## **REVISED DECISION OF THE PLANNING ADMINISTRATOR**

**URBAN GROWTH PRELIMINARY DECLARATION / CLASS 3 SITE PLAN  
REVIEW / CLASS 2 ADJUSTMENT / CLASS 2 DRIVEWAY APPROACH PERMIT  
/ TREE REGULATION VARIANCE CASE NO.: UGA-SPR-ADJ-DAP-TRV22-01**

**SUMMARY:** Development of a new industrial use building with associated site work.

**LOCATION:** 4400 Block of Turner Rd SE

PRELIMINARY SITE PLAN

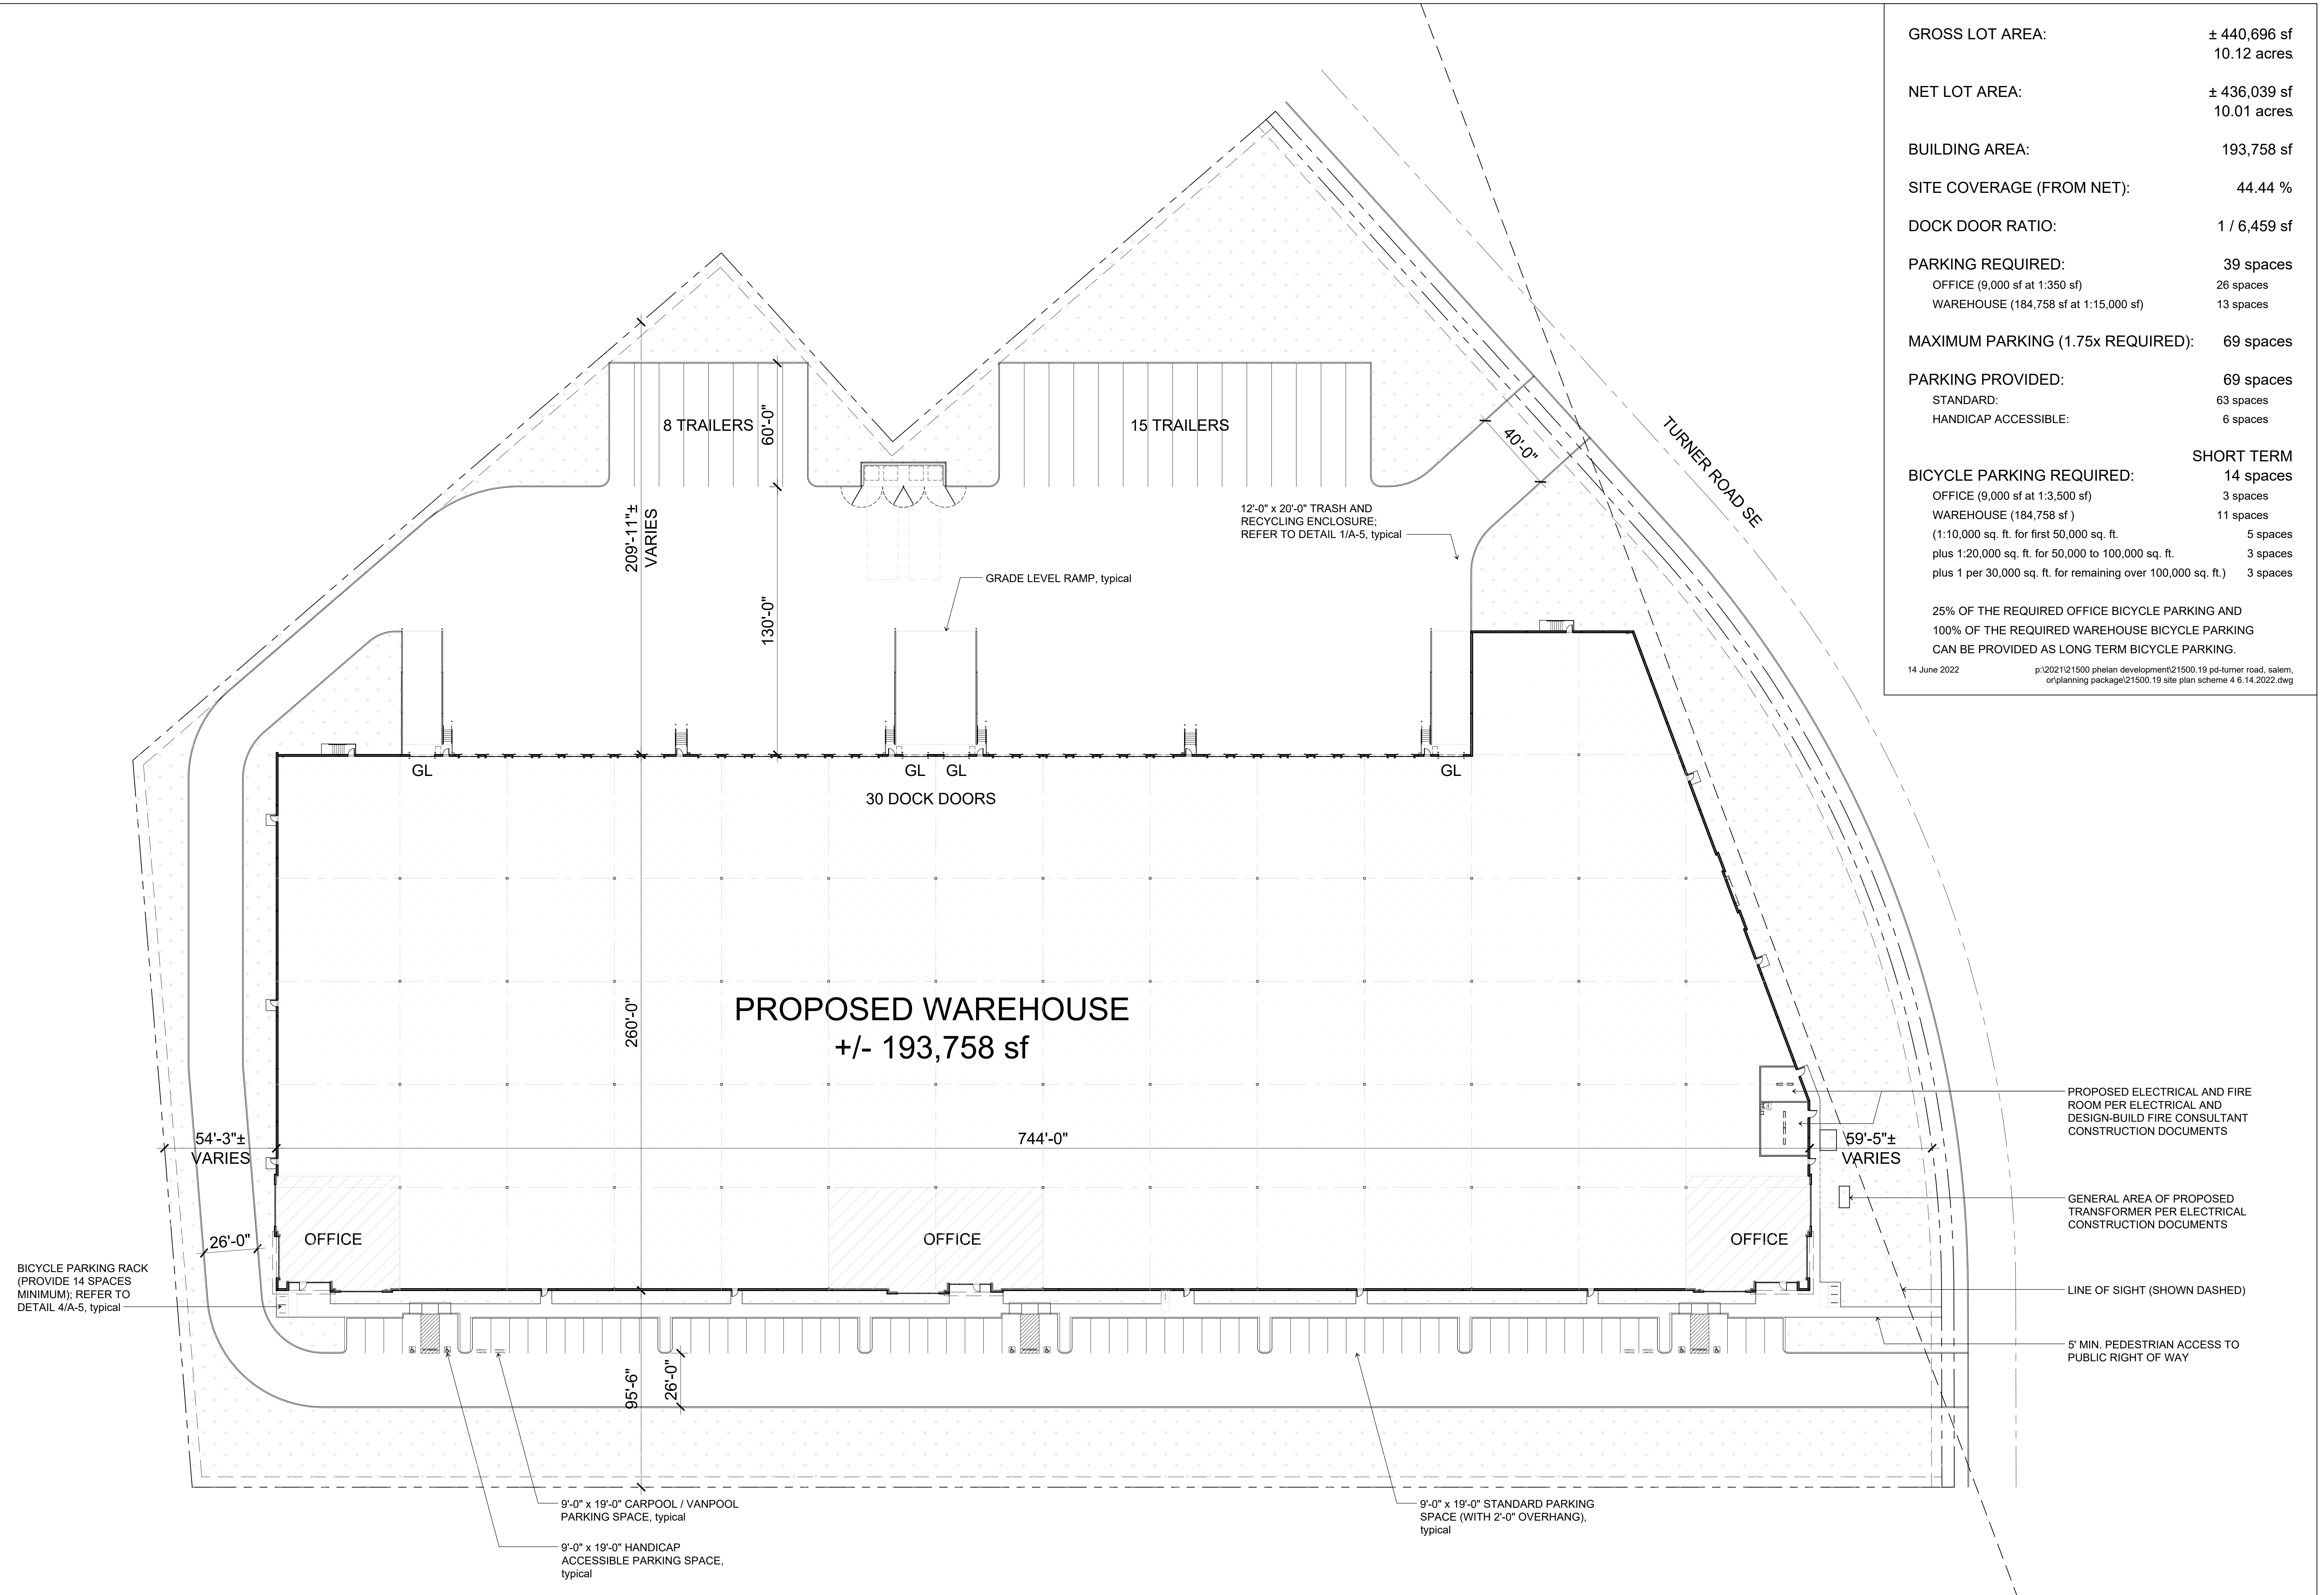
- Condition 3:** At the time of building permit, the applicant shall adjust the parking area to include only the 67 parking spaces allowed by the maximum parking requirement.

- Condition 4:** At the time of building permit review, the applicant shall provide bumper guards or wheel barriers for the parking spaces adjacent to a walkway only five feet in width to prevent parked vehicles from encroaching into the pedestrian accessway.

The proposed site plan indicates that 69 parking spaces will be provided on site, 4 carpool/vanpool parking spaces are indicated on the site plan, and no compact spaces

**Condition 4:** At the time of building permit review, the applicant shall provide bumper guards or wheel barriers for the parking spaces adjacent to a walkway only five feet in width to prevent parked vehicles from encroaching into the pedestrian accessway.

TREE INFORMATION

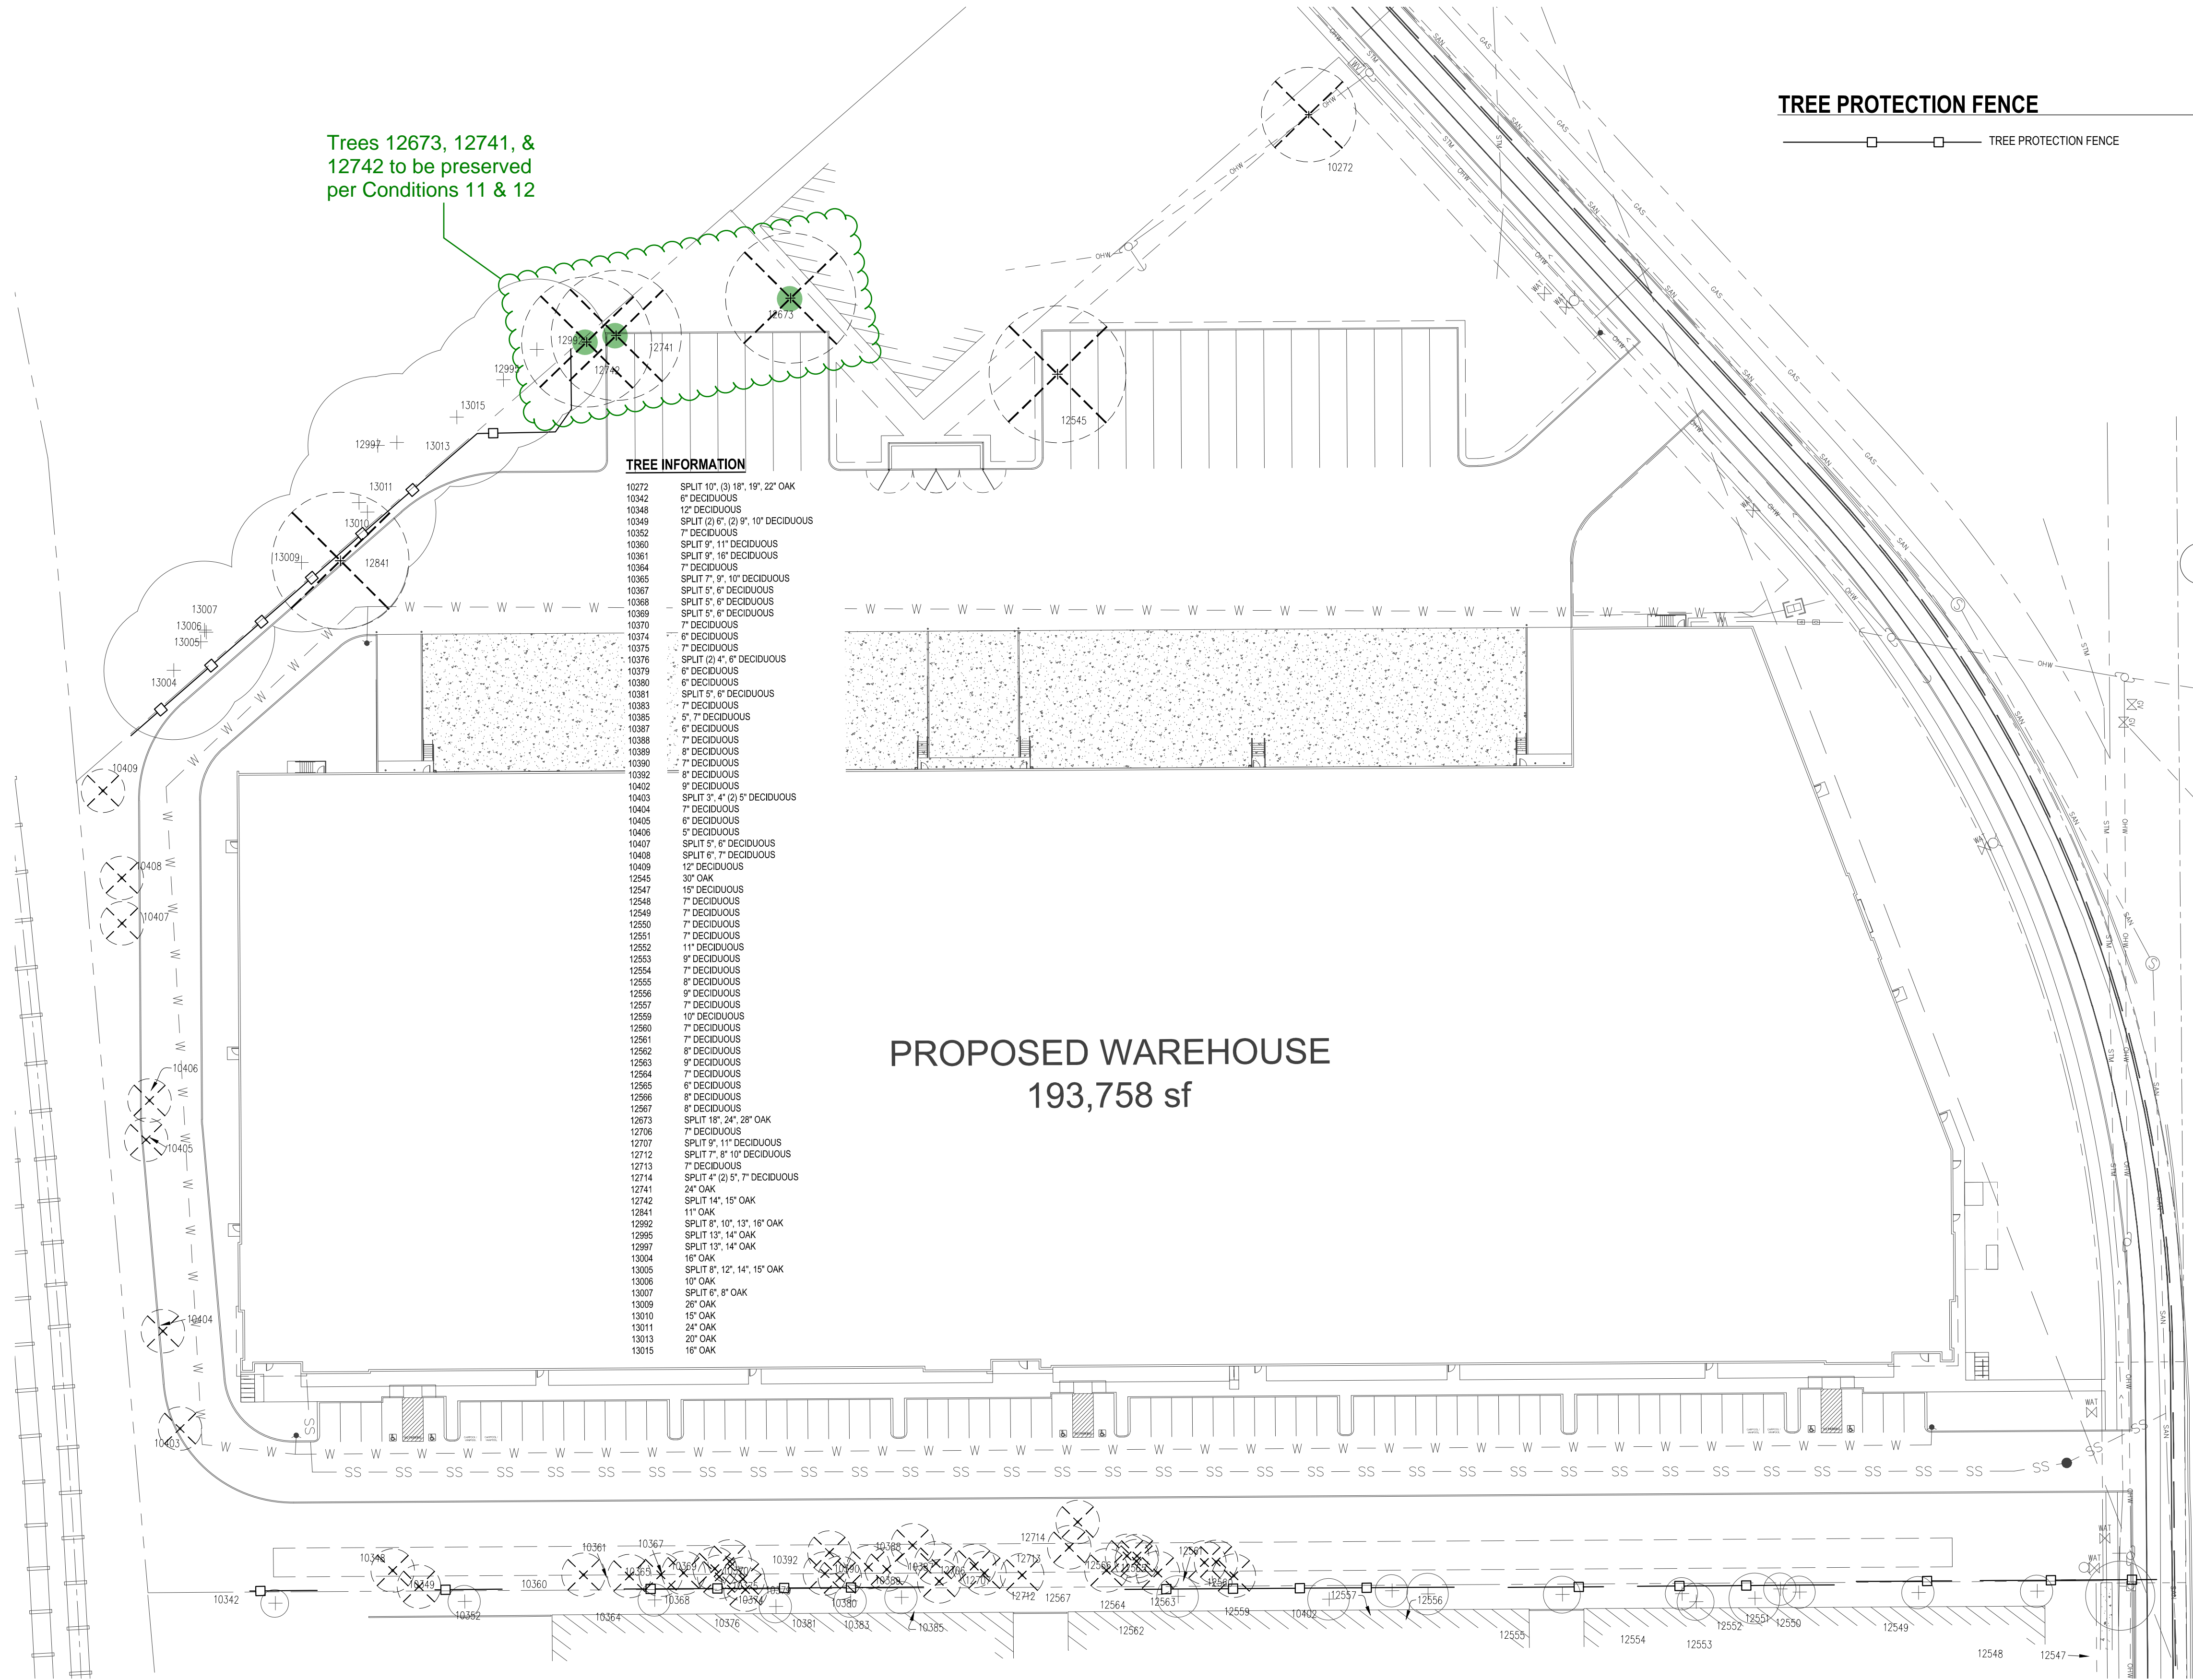
**Finding:** The applicant submitted a tree plan in conjunction with the proposal identifying a total of four significant trees (Oregon White Oak greater than 20 inches in diameter-at-breast height (dbh), or any other tree with a dbh of 30 inches or greater) on the property. In the written statement for the Tree Variance, the applicant requests to remove all four significant trees due to their locations severely limiting the development of the site. However, the applicant proposed minor changes to the site plan after the application was deemed complete and notice was sent, including a request to remove two additional trees under this Tree Variance to accommodate an expanded vehicle use area not required by code; the initial proposal requested removal of only two significant trees. As such, Staff finds that the two additional trees requested for removal do not meet the criteria for hardship, as the site is able to be developed without their removal, as evident with the initial proposal for the development. In addition, the location of the two trees in question, Tree No. 12673 and Tree No. 12741, would only limit the development of an expanded large-vehicle trailer parking or storage area, which is not considered required parking under the Salem Revised Code. The development is still able to provide a separate area of fifteen trailer parking spaces, and an additional eight spaces does not render the development unusable or create an unreasonable hardship. As such, the following condition applies:

The two trees originally proposed for removal and evaluated under this Tree Regulation Variance include: Tree No. 10272 – a split trunk Oregon White Oak with the largest measurement of 22-inch dbh; and Tree No. 12545 – a 30-inch dbh Oregon White Oak. Because both trees have a dbh of 20 inches or greater, they meet the SRC 808.005 definition of a significant tree according to amendments effective March 16, 2022. Significant trees may be removed under a tree and vegetation removal permit issued under SRC 808.030, a tree conservation plan approved under SRC 808.035, or a tree variance granted under SRC 808.045. Because the trees are not hazardous and do not meet criteria for a tree removal permit, this practical difficulty can be most effectively relieved by a variance.

The request to remove these two significant trees is directly related to the need to provide stormwater facilities on site. The trees are located within the proposed stormwater facility area and would interfere with providing the necessary infrastructure to meet standards. The preliminary stormwater design demonstrates the use of green stormwater infrastructure to the maximum extent feasible and demonstrates compliance with Stormwater PWDS Appendix 004-E(4) and SRC Chapter 71. There are no other options to provide the required stormwater facilities on site; retaining the trees creates an unreasonable hardship that can most effectively be relieved by approval of the variance.

**Condition 11:** Two significant trees, a split trunk Oregon White Oak with the largest measurement of 28 inches dbh (Tree No. 12673) and a 30-inch dbh Oregon White Oak (Tree No. 12741), shall be retained and preserved on site, with the required protection measures provided for significant trees during construction (SRC 808.046). At the time of building permit review, the applicant shall provide updated landscaping indicating the critical root zone of these trees and all protection measures, and updated plans reducing the trailer parking area to ensure protection of these trees.
